Initial Project Review

Preliminary Plat: Harbor Run

Application Number: 939769

Proposed Site Plan

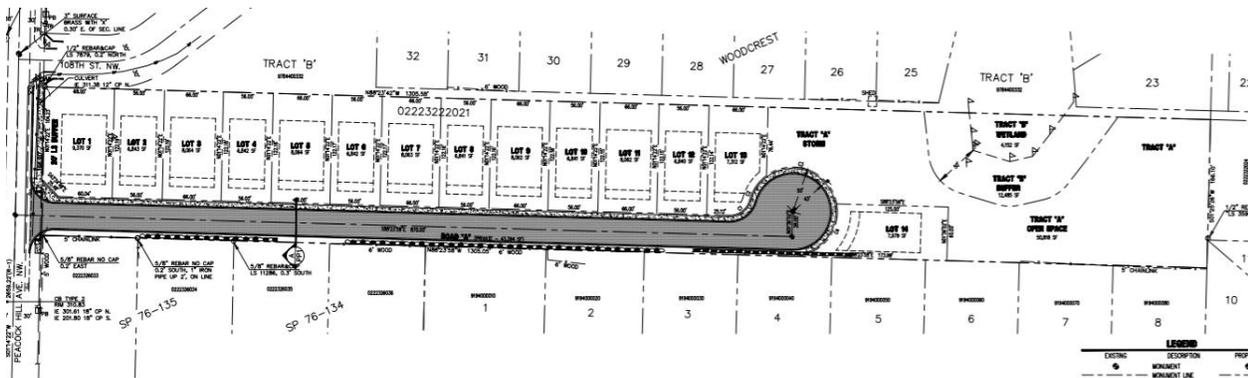
Staff Comment: The net developable acreage for the property is 3.88 acres. The minimum density is 16 dwelling units. In the most recently submitted design, the applicant is proposing 14 lots for the benefit of detached single-family residences. They are requesting that the critical area buffers be excluded from the net developable acre calculation because the project cannot fit additional dwelling units on the property because of the need for tree retention/preservation, storm water control, on-site sanitary sewers, road standards and the critical areas. If the critical area buffers are subtracted, then 14 dwelling units would be minimum density.

Planning Staff does not agree that the applicant cannot meet minimum density. The area designated for Lot 1 through Lot 13 is approximately 98,582 square feet. All the lots within this area are a little over 122 feet in depth. With a minimum lot size of 5,000 square feet, and a depth of 122 feet with a width of 40.98 feet, approximately 19.7 lots, rounded down to 19, could be placed with the same area as Lot 1 through Lot 13. This is greater than the necessary 16 needed to meet minimum density which would permit some flexibility with lots sizes and widths. Additionally, it would still allow the stormwater facilities to be placed just north of the cul-de-sac as currently proposed. If septic systems are required, then lots in excess of the density permitted with on-site septic can be shadow platted to place the systems on and developed with residences once sewer becomes available. This would also allow the majority of Tract A to remain forested and undeveloped for the benefit of tree retention/preservation.
